Fowley Cottage, 46 Warblington Road, Emsworth, PO10 7HH

Application Ref. APP/23/01078

We are instructed [REDACTED] to submit a further **OBJECTION** to the above-referenced planning application.

Figure 1 – Tight manoeuvre for refuse vehicle

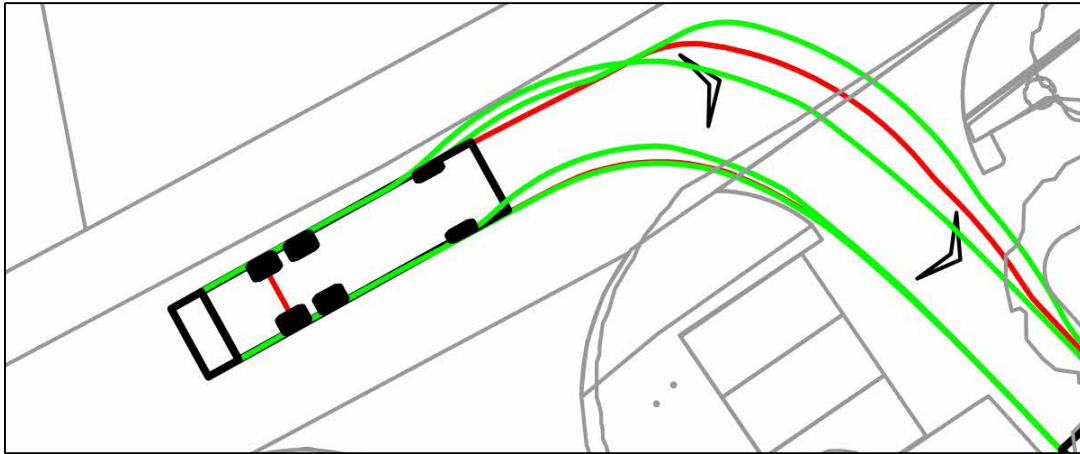
We have reviewed the updated consultation response from the Highway Authority dated 10 June 2024 and note concerns regarding the tight arrangement of the proposed refuse tracking as shown on Drawing Ref. 5970/206 Rev A. The applicant has submitted updated refuse tracking (Drawing Ref.

5970/206 Rev B) to address these concerns, including increased clearance from parking to the west of the site access. However, the manoeuvre as shown at Figure 1 below leaves no margin between the body of the vehicle and the footway on Warblington Road. with very limited margin to parking bays and no margin to boundary features. We note that the applicant has resisted the Highway Authority's request for an independent Road Safety Audit (RSA) as these internal areas are private (unadopted). Highway safety is a relevant planning consideration regardless of legal status of highway. Having requested an RSA, clearly the Highway Authority have concerns and in the absence of an RSA the Council cannot be certain that the internal access arrangement is safe for all road users in accordance with 115 of the NPPF.

Figure 3 – allocated/unallocated on plot parking arrangement

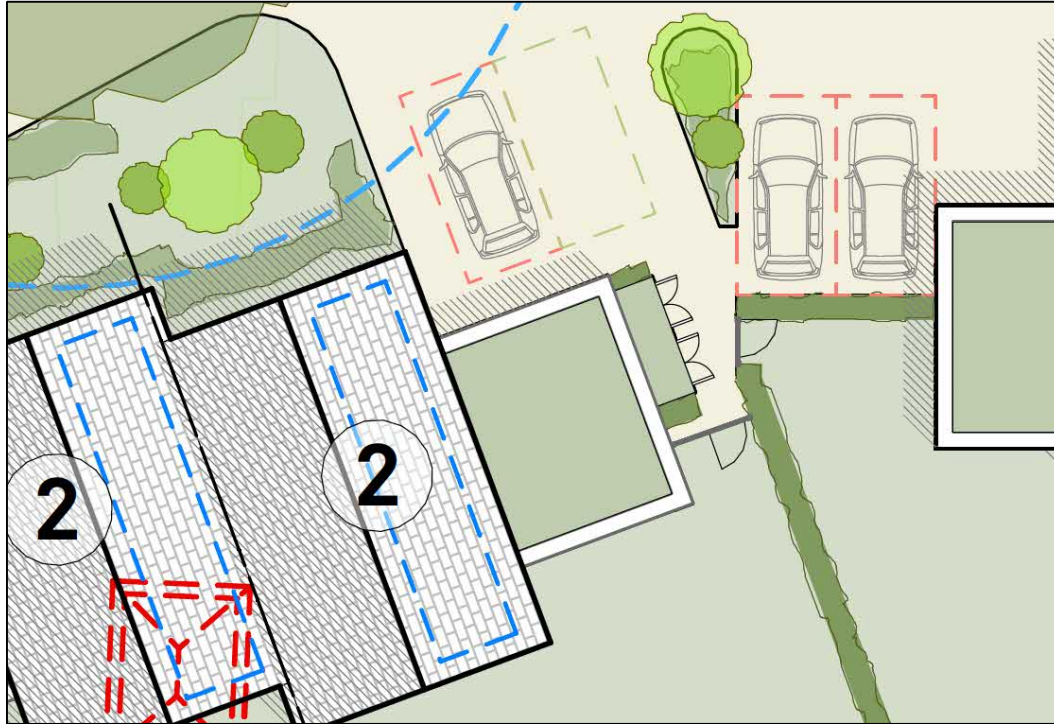
The various design changes have not addressed our concerns regarding the applicant's approach to allocated and unallocated parking. The flats have unallocated parking, which is common for this type of accommodation. This is denoted by a green dashed outline. Most of the proposed houses have allocated on-plot parking, as you would expect in this location. This is denoted by a red dashed outline. However, two of the 3-bedroom houses have combined allocated and unallocated on-plot parking – an example is shown at Figure 3 below.

This arrangement is completely impractical as the unallocated spaces on these plots will not be available for other residents of the site – inevitably these spaces will be used as allocated spaces for the two plots they relate to. This being the case, the proposal does not provide sufficient parking. The unallocated parking demand for the flats is 5.2 spaces and the guidance confirms that this should be rounded up to 6 spaces. The allocated parking demand for the houses is 25 spaces. The visitor demand at 20% of the total compliant parking provision (31 spaces) is 7 spaces (rounded up from 6.2 spaces). Therefore, the total parking demand for the site is 38no. spaces and the current provision remains 1no. spaces short of this requirement. Given the tight nature of the internal access arrangement, there is no space for informal overflow parking to make up this shortfall and any overflow parking on Warblington Road will make the site inaccessible to refuse vehicles. Furthermore the deficiency in on-site parking provision will be exacerbated by the use of parking spaces to store boats, kayaks, boat trailers and recreational vehicles, for which no separate provision is made (apart from in gardens). Those living in this area generally are likely to have this equipment due to the proximity to the foreshore.
